**Part Change Notice****Date: Feb. 09, 2016****PCN. No: 1602012****Products:**

CDP-RX-02E-R, EP-R, F-R, FP-R 434 MHz.

**CDP-RX-02 CURRENT**

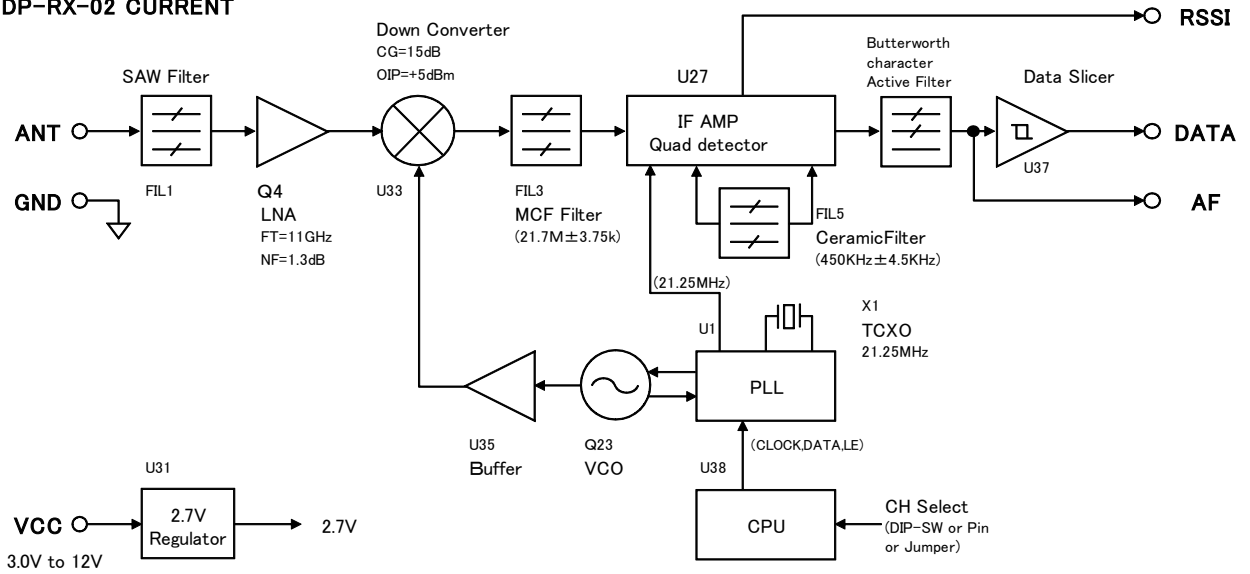
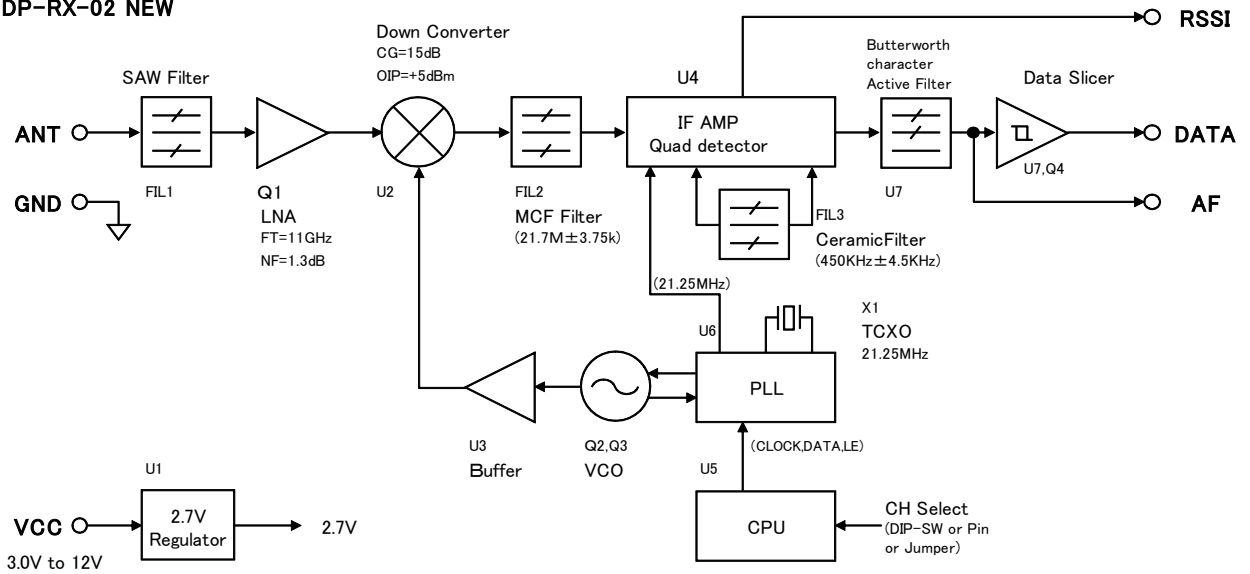
- Obsolete components change:  
VCO circuit components and IF-IC\* component change  
Comparison block diagrams are attached.

### RSSI Characteristics (New)

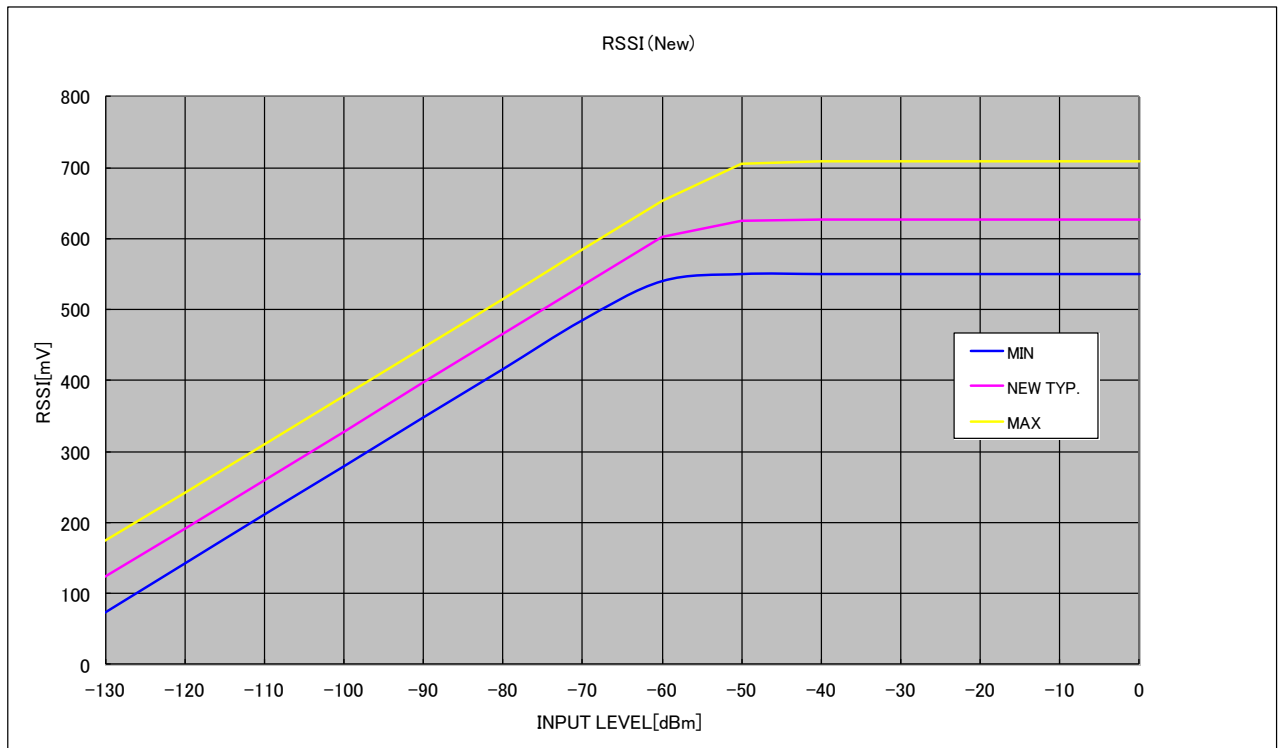
\* The impact of changing IF-IC on the RSSI specification and characteristics is as follows:

Current: 235mV $\pm$ 40mV at -110dBm195mV $\pm$ 40mV at -116dBmNew: 230mV $\pm$ 50mV at -113dBm

RSSI characteristics change: Wider variation in RSSI output (Comparison figures are attached)
